PCN (Product Change Notice)																																				
<input type="checkbox"/> Major Change <input checked="" type="checkbox"/> Minor Change																																				
PCN Number: PCN_ConPSHD_20250719 Affected Series: WR-PSHD Affected Part Number: see table below PCN Date: 2025-04-19 (YYYY-MM-DD) Effective Date: 2025-07-19 (YYYY-MM-DD)	Change Category: <input type="checkbox"/> Equipment/Location <input checked="" type="checkbox"/> General Data <input type="checkbox"/> Material <input type="checkbox"/> Process <input type="checkbox"/> Product Design <input type="checkbox"/> Shipping/Packaging <input type="checkbox"/> Supplier <input type="checkbox"/> Software																																			
Contact: Product Management Phone: +49 (0) 7942 - 945 5001 Fax: +49 (0) 7942 - 945 5179 E-Mail: pcn.eican@we-online.com	Datasheet Change: <input checked="" type="checkbox"/> Yes <input type="checkbox"/> No Attachment: <input type="checkbox"/> Yes <input checked="" type="checkbox"/> No																																			
DESCRIPTION OF CHANGE: <p>Because of a database mismatch, Würth Elektronik eiSos will correct the tolerances of the product dimensions & recommended land patt

1. 6100xx21121

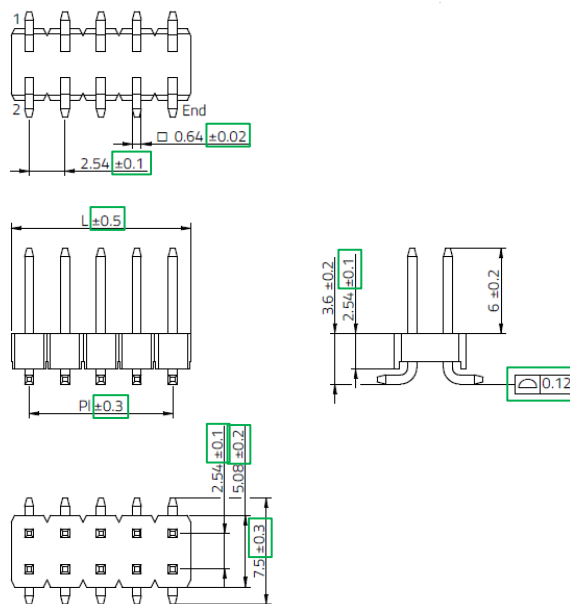
DIMENSIONS

BEFORE CHANGE

AFTER CHANGE

RECOMMENDED LAND PATTERN :

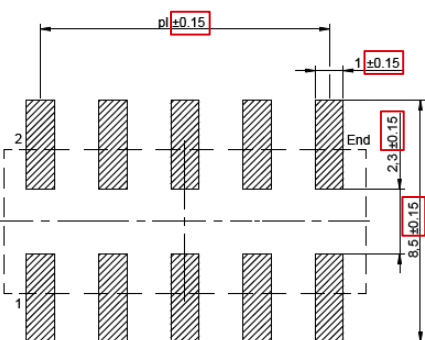
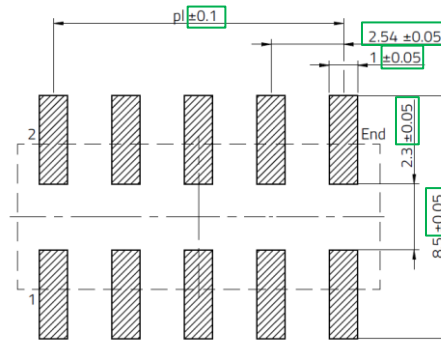
BEFORE CHANGE

AFTER CHANGE

2. 6103xx21121

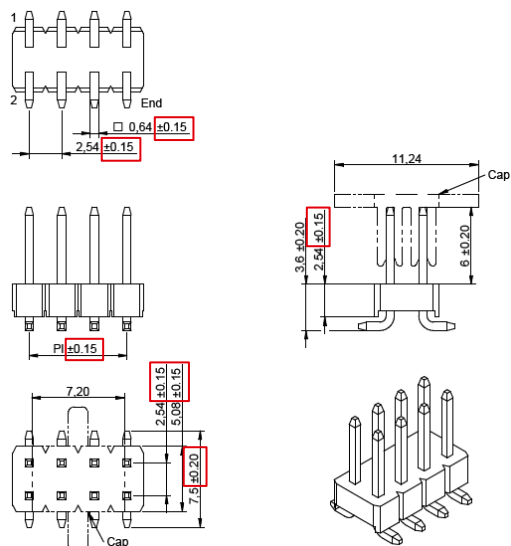
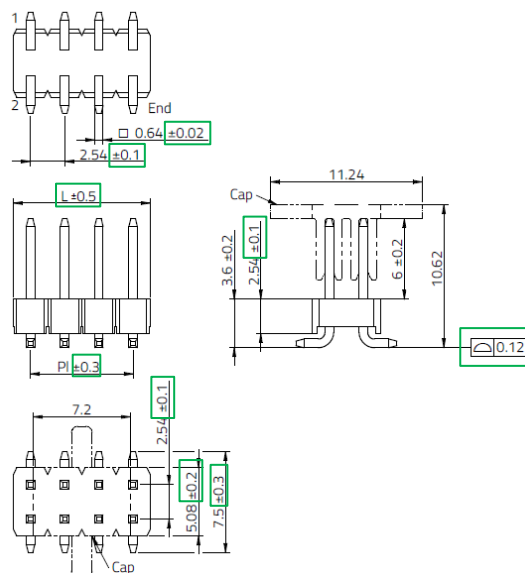
DIMENSIONS

BEFORE CHANGE

AFTER CHANGE

RECOMMENDED LAND PATTERN

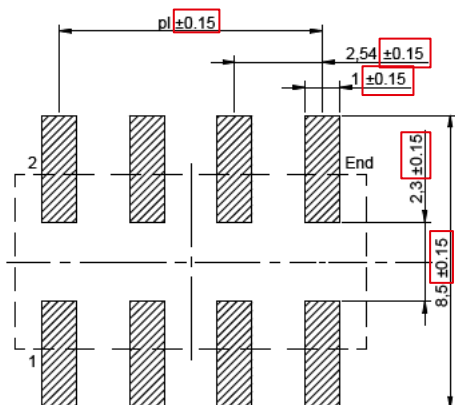
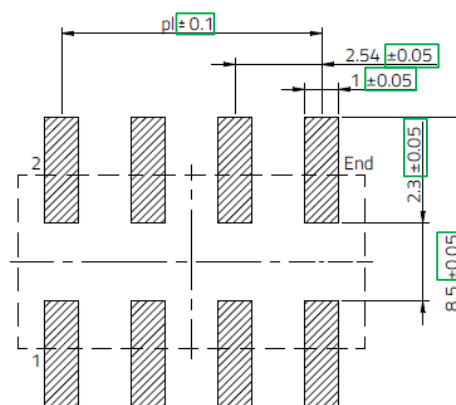
BEFORE CHANGE

AFTER CHANGE
